Appendix | 2
Drainage Design Report

Proposed Drainage Facilities
Lot No. 110 in D.D.219,
Sai Kung,
New Territories,

Response to DSD's Comments

DSD's Comments (as at 4.7.2024), The Chief Engineer/Mainland South, Drainage Services Department (CE/MS, DSD) (Contact Officer: Mr. Henry YEUNG, Tel: 2300 1343)	Our Response to DSD's Comments
4(a) peripheral drainage channels should be provided to intercept the surface runoff from the uphill catchment so as to avoid the application site from overland flow influence;	A 375UC is provided at the lot boundary facing the uphill catchment to intercept surface runoff. Please refer to the Drainage Layout Plan in Appendix A.
4(b) the applicant should demonstrate with the support of hydraulic calculation, that the proposed drainage system has adequate capacity to accommodate the surface runoff collected from its catchment, the application site and its upstream catchments;	The catchment area and the drainage proposal are detailed in the Drainage Design Report (DDR).
4(c) the applicant should critically review the proposed drainage system and propose drainage mitigation measures to prevent the potential flooding risk arising from surface runoff runni

DWG. TITLE : DRAINAGE LAYOUT PLAN AND BLOCK PLAN

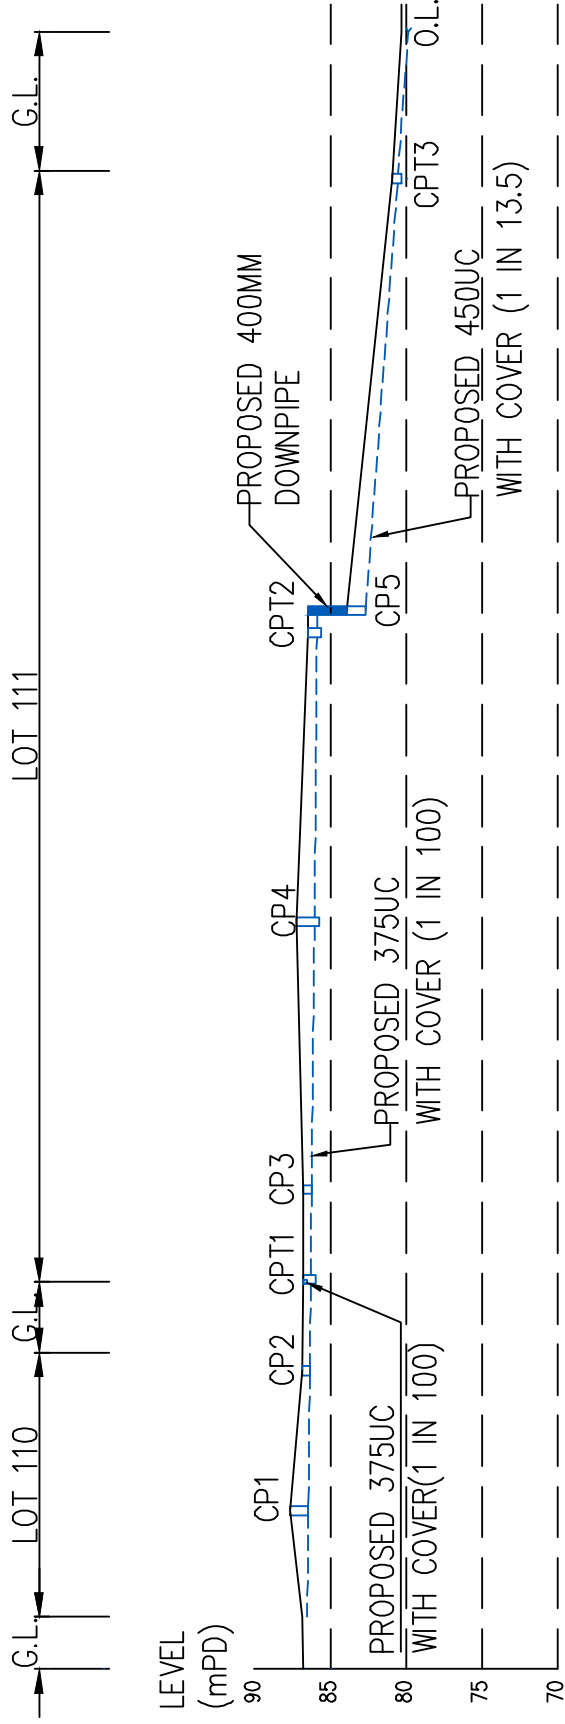
inclement weather;	Intensity-Duration-Frequency Curves with Provision for Climate Change for SLOPE Drainage Design(IDF+28.1%), please refer to the content of DDR.
4(d) a sand trap/catchpit should be provided and regularly desilted by the applicant or the successive owners of the proposed development to prevent sand and silt from being washed into the existing drainage system/channel at is downstream;	Noted. Multiple sand traps/catchpits are provided along the proposed drainage facilities. Please refer to the Drainage Layout Plan in Appendix A.
4(e) there is no existing DSD foul sewer in the vicinity of the subject site;	Noted.
4(f) the applicant shall be responsible for the maintenance of his completed drainage works and, if required in future by DLO/SK, relocation of such works;	Noted and agreed.
4(g) the applicant shall allow all time free access for the Government and its agent to conduct audit on his completed drainage works;	Noted and agreed.

It is concluded that a 375UC (1 in 100 fall) is provided in the upper section from Lot 110 to Catchpit With Trap 2 (CPT2), which is connected by a 400mm downpipe, leading to a 450UC (1 in 13.5 fall) in the lower section of the facilities. Please refer to Appendix A for the layout plan and details.
